ADDENDUM

DC204357

New primary school, childrens centre, temporary classroom, new access from Mill lane, hard and soft playing space, vehicle turning areas and drop off, staff and visitor parking (Amended Plans).

Land at rear of Harcourt Street/Mill Lane, Reddish, Stockport.

North Reddish School, Mill Lane, Reddish Access, Footway and Turning Area 1:500 At A3 Plan DC024357/NDW/1

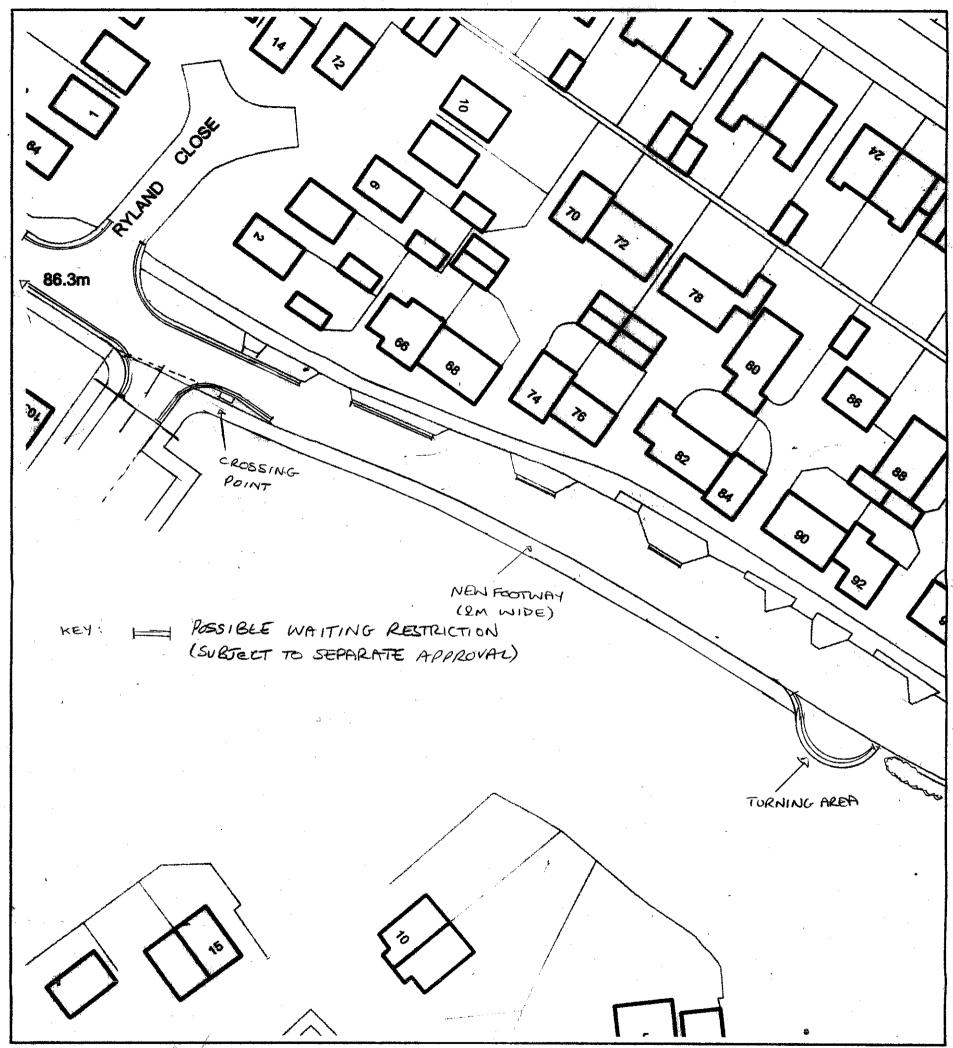
Following a second site visit a plan showing a suggested new footway, turning area and site access has been produced (plan DC024357/NDW/1). This includes a footway of length 100m east of the boundary of 103 Mill Lane and a small turning area for light vehicles. This will allow parents to drive up Mill Lane, turn and park up for a short period to drop off / collect children and will augment the drop off area within the school grounds. Construction of the footway will require removal of some small trees and scrubs opposite 82/84 Mill Lane but should not effect the poplar trees which are set a minimum of 3.8m back from the footway edge. The construction of the turning area will require removal of some trees which should be replaced behind the turning area. The main body of the hawthorn hedge starts 116m from the boundary of 103 Mill Lane and is not effected by these works. The access junction is shown. This includes junction radii of 4.5m and a slight build-out on the eastern side of the junction to help pedestrians crossing Mill Lane. The extent of recommended waiting restrictions on Mill Lane is also included on the plan. These include an order to protect the turning area, to prevent waiting opposite the new footway and to protect the site access and the junction of Ryland Close. The order could be extended from the school access up to the junction with Windmill Lane on the south side of the road to protect access to driveways. The Traffic Regulation Orders (TRO's) for the waiting restrictions will need to be the subject of a separate report to the Tame Valley Area Committee which may also need to include School Keep Clear markings for the pedestrian access to Harcourt Street.
